**Change Order No. 2
Attachment**

PROJECT: Additions and Alterations **PROPOSAL REQUEST NO.:** **01**
(name, address) **Hurricane Deck Elementary**
16594 N State Highway 5
Sunrise Beach MO 65079 (one)

OWNER: **Camdenton R-III School District** **DATE:** January 07, 2014
P. O. Box 1409
Camdenton MO 65020

CONTRACT DATE: November 11, 2013 **ARCHITECT'S PROJECT NO.:** 3-13021.00

Drawing No.
SD-M1-2

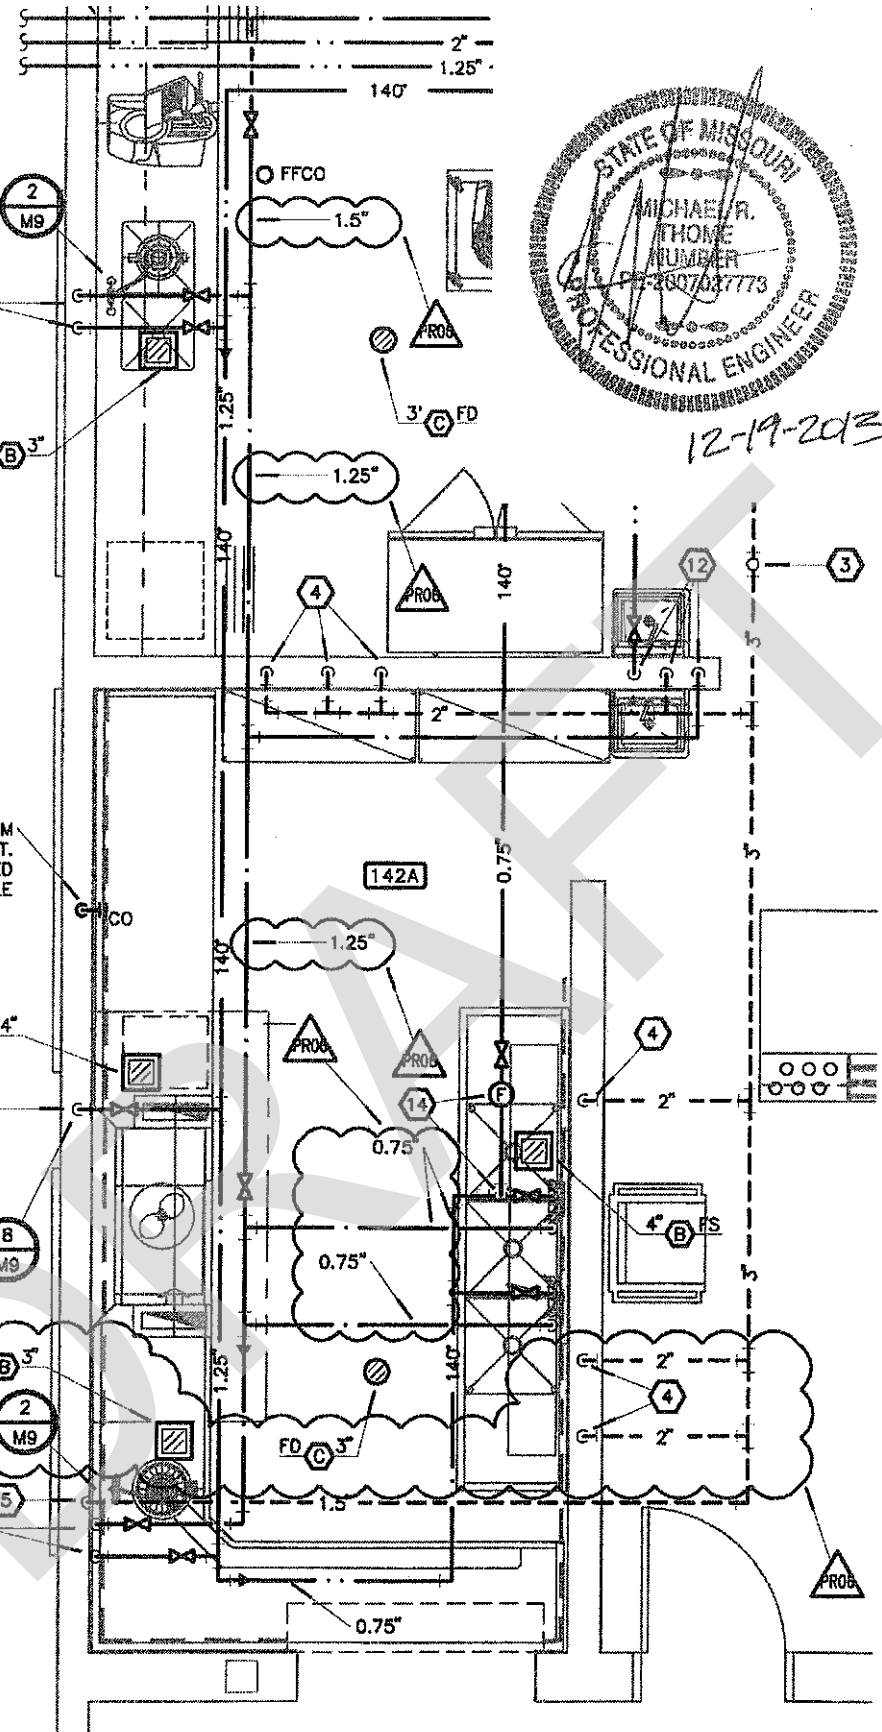
Revise plumbing requirements due to kitchen equipment layout revision.

1. Reference Sheet M1, "Area "A" Below Grade Plumbing Plan, 1/M1":
 - a. Add grease waste and vent for floor sink serving scrapmaster.
2. Reference Sheet M9, "Enlarged Kitchen Above Grade Plumbing Plan, 1/M9":
 - a. Add floor sink below scrapmaster.
 - b. Revise piping serving scrapmaster and pre-rinse faucet.
 - c. Include clarification on size of domestic cold water serving dishwashing area.

asi # 003
Drawing No.
SD-C04

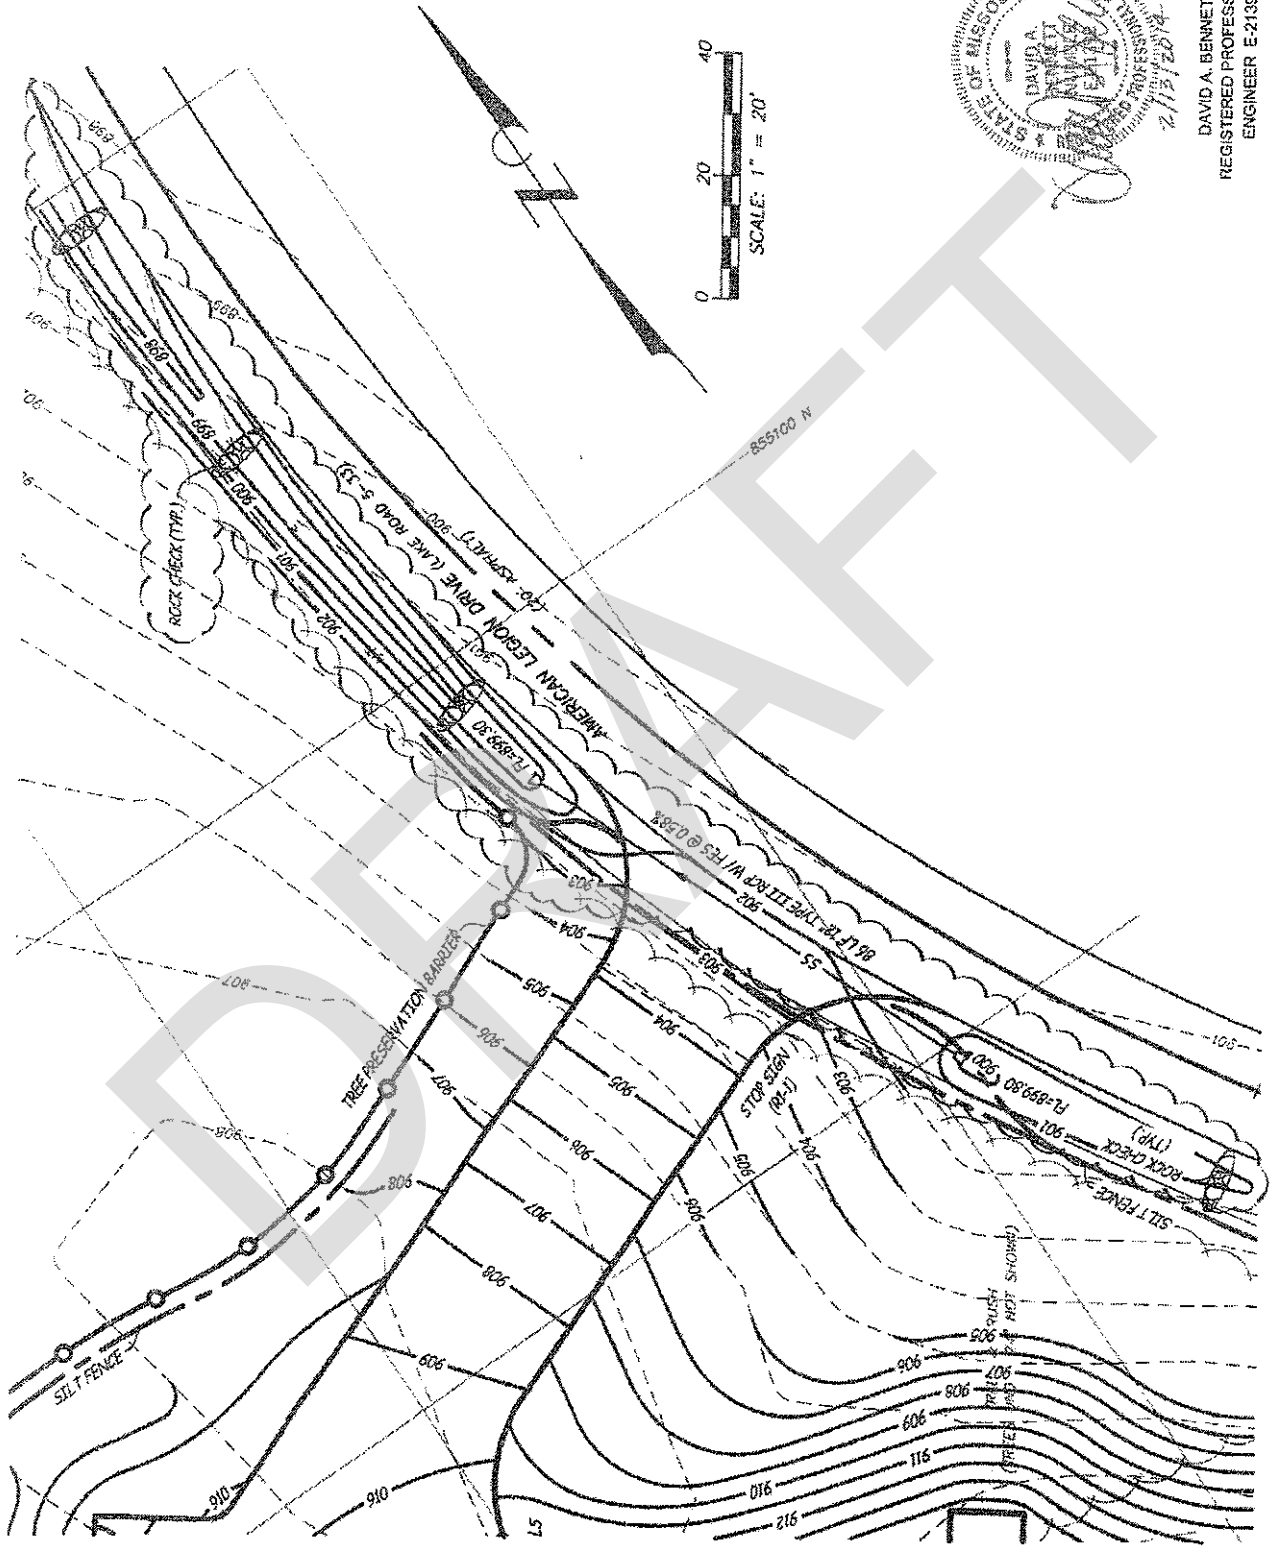
Description: Added 12 inch reinforced concrete pipe (RCP) culvert under northern driveway to bus parking area.
